**Committee of Experts on the Transport of Dangerous Goods
and on the Globally Harmonized System of Classification
and Labelling of Chemicals**

**Comments on documents ST/SG/AC.10/C.3/2022/50 –
ST/SG/AC.10/C.4/2022/10 and informal documents INF.20
(TDG) – INF.12 (GHS): Classification of desensitized
explosives according to the GHS**

Transmitted by the expert from the United Kingdom

2. However, the United Kingdom believes that the proposal as presented in ST/SG/AC.10/C.3/2022/50 – ST/SG/AC.10/C.4/2022/10 could be further improved for clarity. The proposed improvements to Chapter 2.17 (paragraphs 2.17.2 and 2.17.4.1) and Section 51 of the Manual of Tests and Criteria are presented below for consideration by the sub-committees.

Decision logic 2.17.1 for desensitized explosives

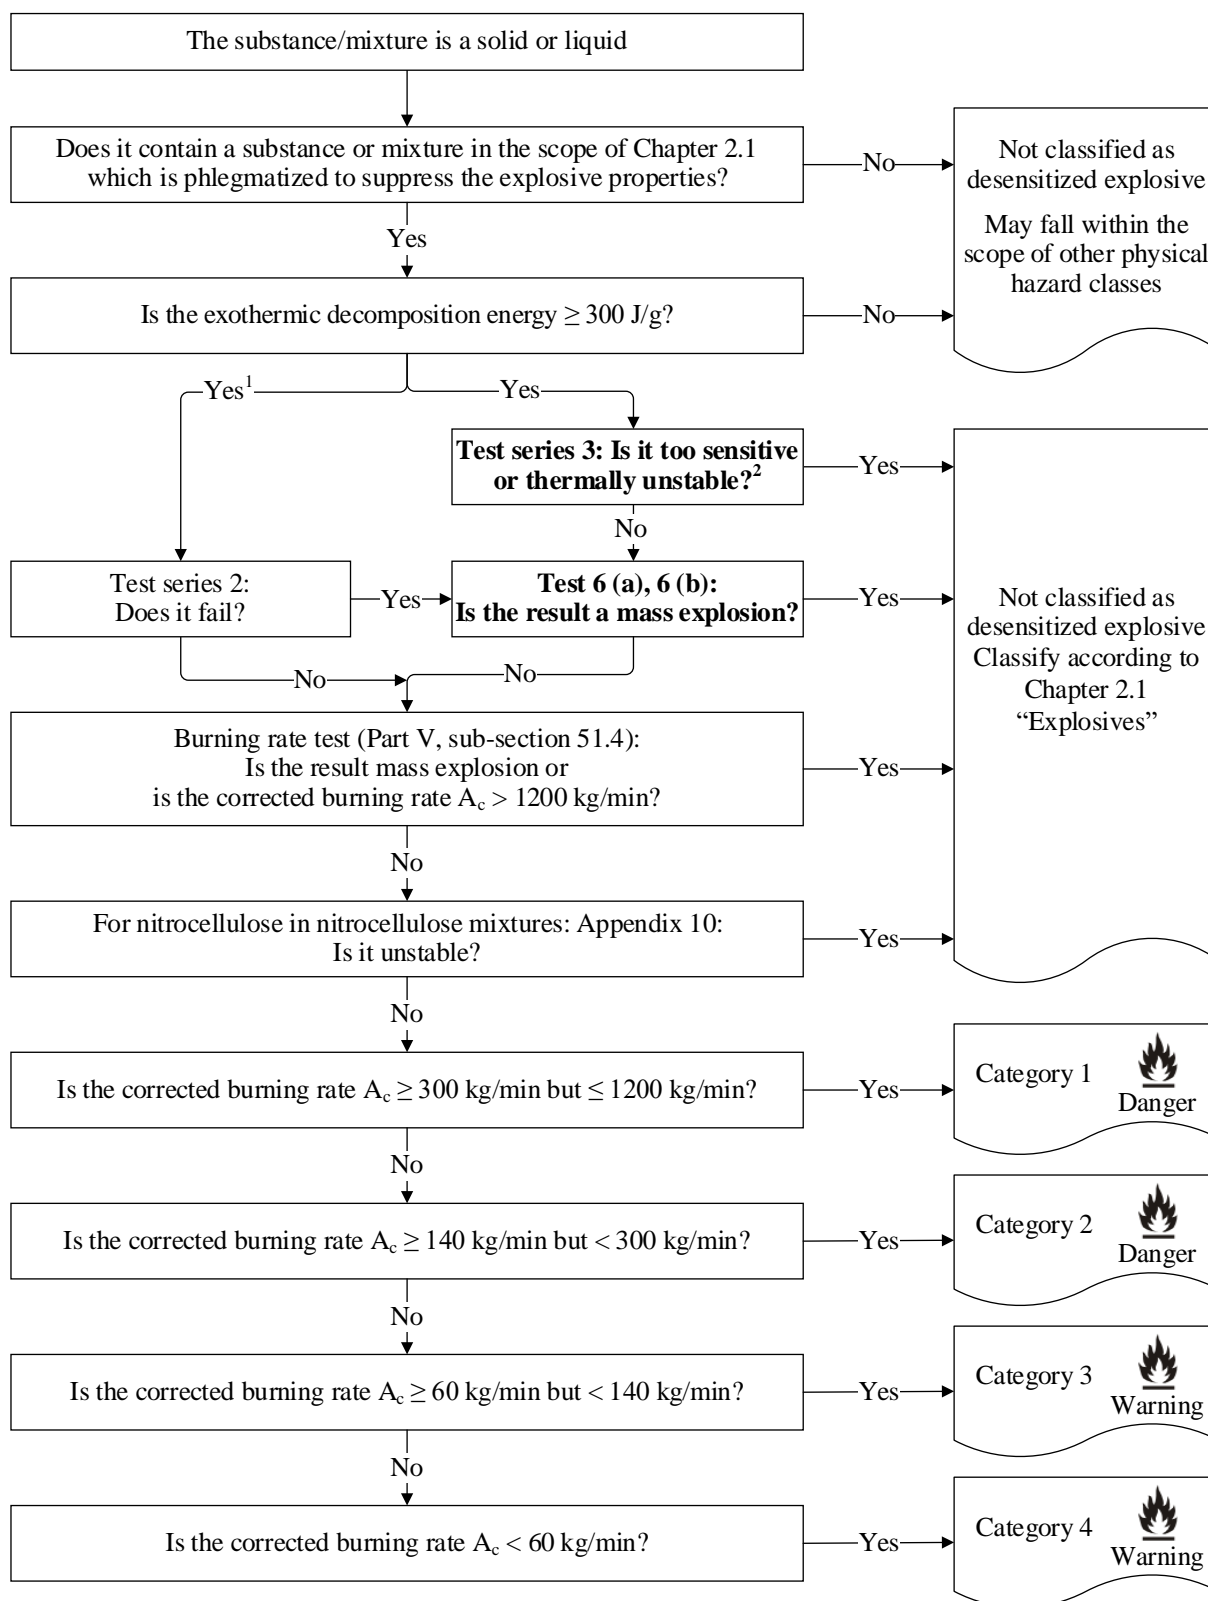
[Amend footnote 2 to decision logic 2.17.1 as follows:

“² Test 3 (c) is not applicable to nitrocellulose mixtures containing no explosives other than nitrocellulose.”]

² Test 3 (c) is not applicable to nitrocellulose mixtures containing no **other** explosives **other** than nitrocellulose.
